GROWTH MANAGEMENT DEPARTMENT STAFF REPORT
PALM VALLEY OVERLAY DISTRICT
March 27, 2024 Public Meeting
ARCCC 2024-02 Community Center at Bethel Point

To: Architectural Review Committee
Staff: Brandon Tirado, Planner
Date: March 15, 2024

Summary of Request: Applicant is requesting design approval to renovate and expand the existing Ponte Vedra Concert Hall (PVCH), located at 1050 A1A N. This expansion is limited to primarily the front portion Concert Hall (facing A1A N.), as well as the side outdoor patio area. The applicant has confirmed they will be providing physical color/material samples for the Board to review at the hearing.

Figure 1. Proposed Site Plan

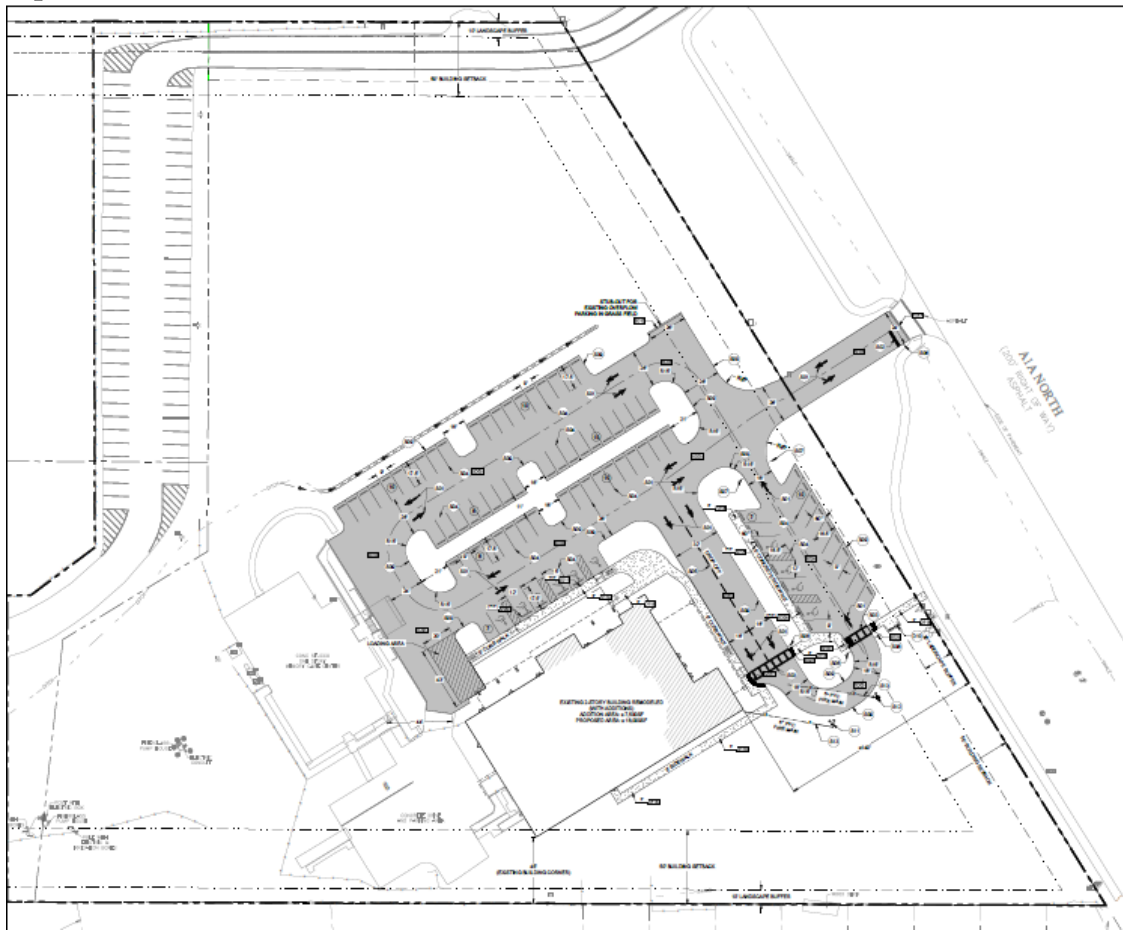
Planning Division: The subject property is located on the west side of A1A N, approximately 0.70 miles north of the intersection of Micklers Road and A1A N. The site is 19.50 acres in size. The layout of the proposed expansion/renovation is indicated on **Figure 1** provided below. Note the hatching on the site plan within the footprint of the building indicates the location of the expansions. Additionally, per Section 3.06.03 of the LDC, it is the charge of this Committee to only consider, these regulations to portion being added, remodeled, renovated or changed:

Figure 3. Ponte Vedra Concert Hall Renders Cont.

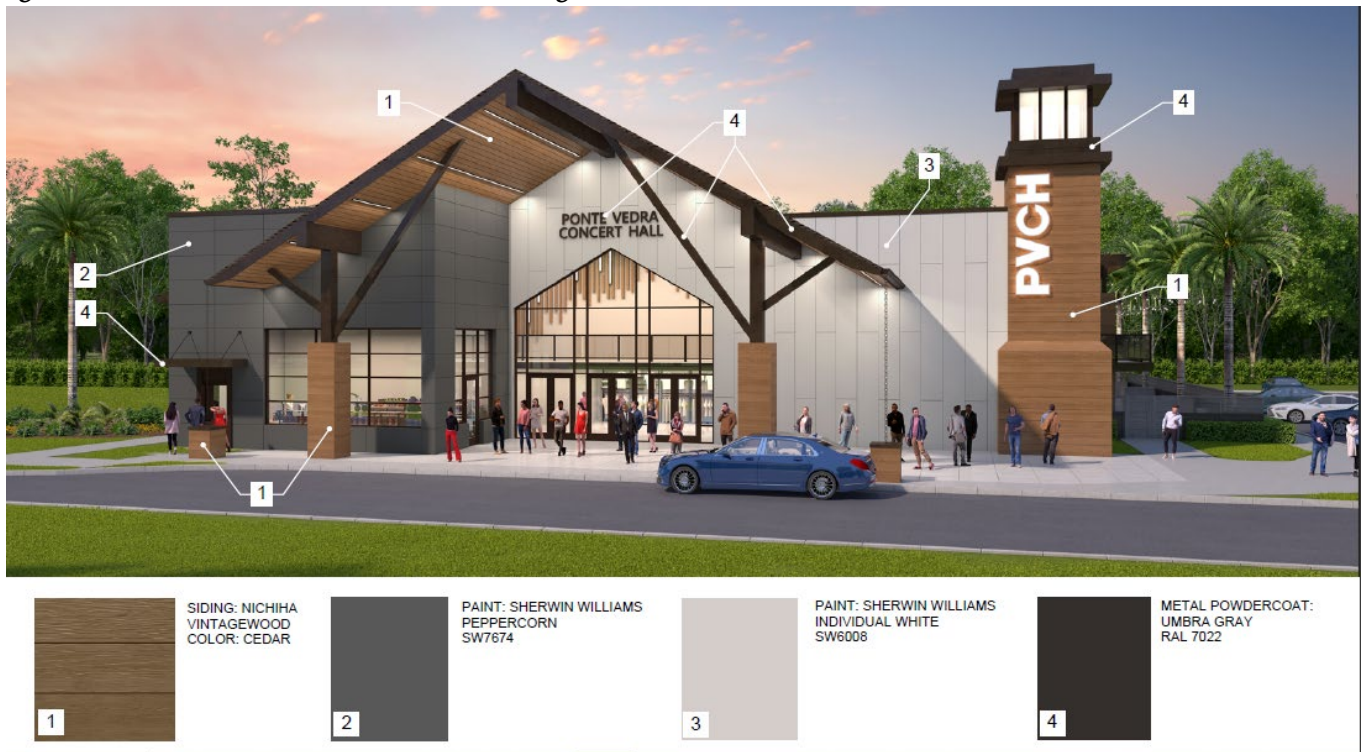
Staff notes these two rendering display a large wall signs that are not and will not be approved until plans are submitted to the County and the application has been fully reviewed by Staff and submitted to PVARC for a motion. However, the renderings do display the wood accents along the building, the large glass windows along the lobby/merchandise areas, as well newly proposed lighthouse style structure (which will have the ability to be illuminated), new fenced outdoor patio area with associated landscaping and lights, and the new 2nd story balconies. The colors being utilized in all of these features has been included in the bottom of **Figure 2**. Staff has requested that the applicant bring samples of all design criteria for Committee approval.

Figure 4. Landscape Plan

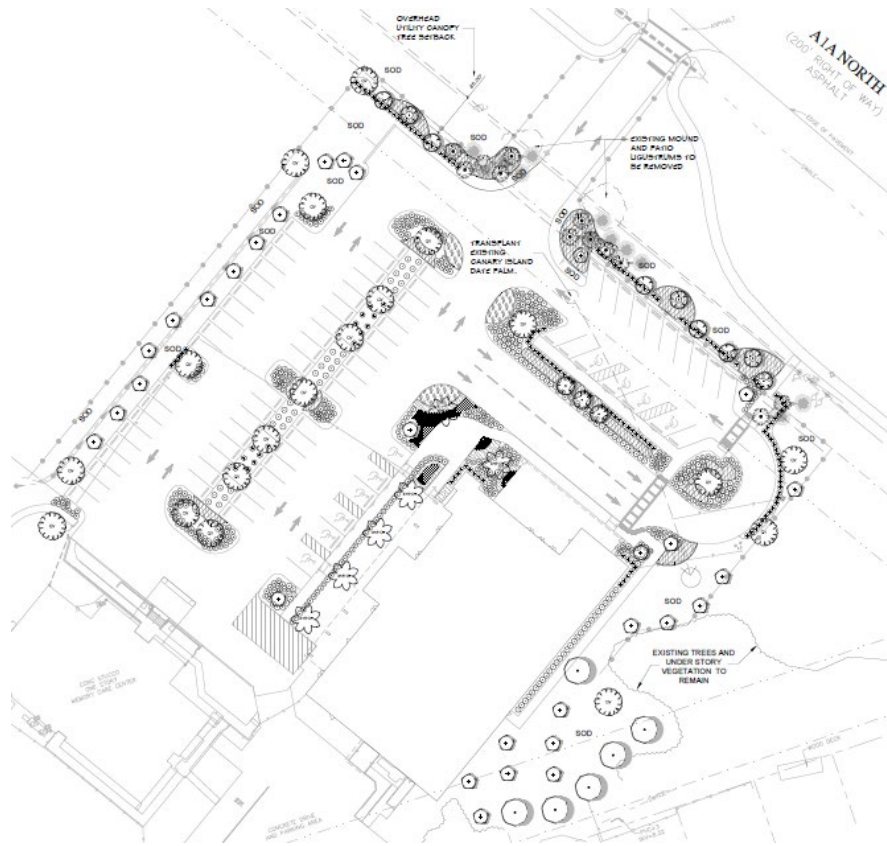
Due to the size of the plans, Staff is unable to fully display the Landscape and Photometric Plans within **Figures 4 & 5**. Full versions of the plans and all of the supporting documents will be attached to this Staff Report.
